SOURCE/REF DRAWING: 700-001-152,B

TITLE: MODIFICATION- DIGITAL OUTPUT ACCESS

NUMBER: 100-061-975

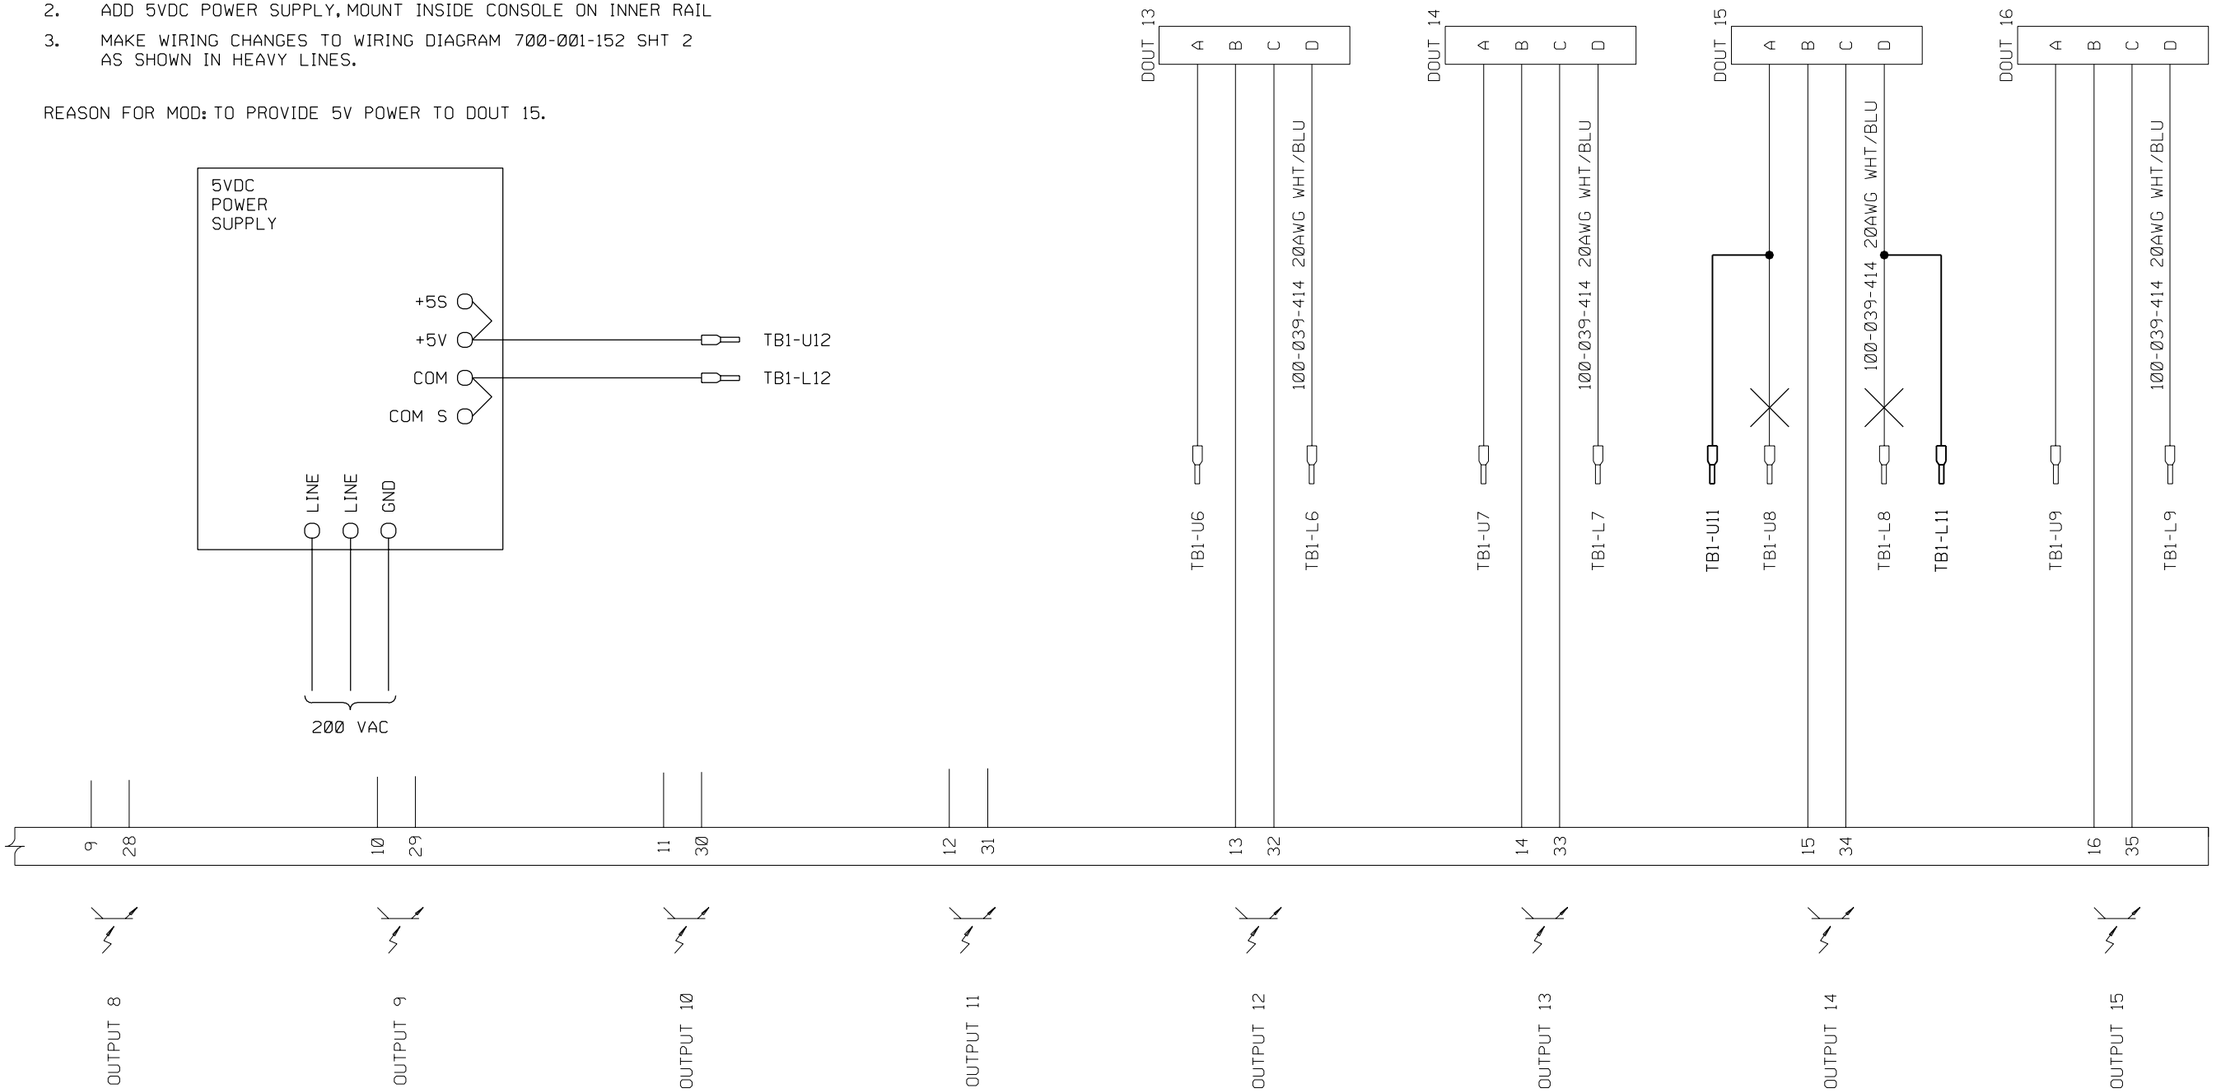
1. SEE DRAWING 700-001-152 FOR FULL WIRING DIAGRAM.
2. ADD 5VDC POWER SUPPLY, MOUNT INSIDE CONSOLE ON INNER RAIL
3. MAKE WIRING CHANGES TO WIRING DIAGRAM 700-001-152 SHT 2 AS SHOWN IN HEAVY LINES.

REASON FOR MOD: TO PROVIDE 5V POWER TO DOUT 15.
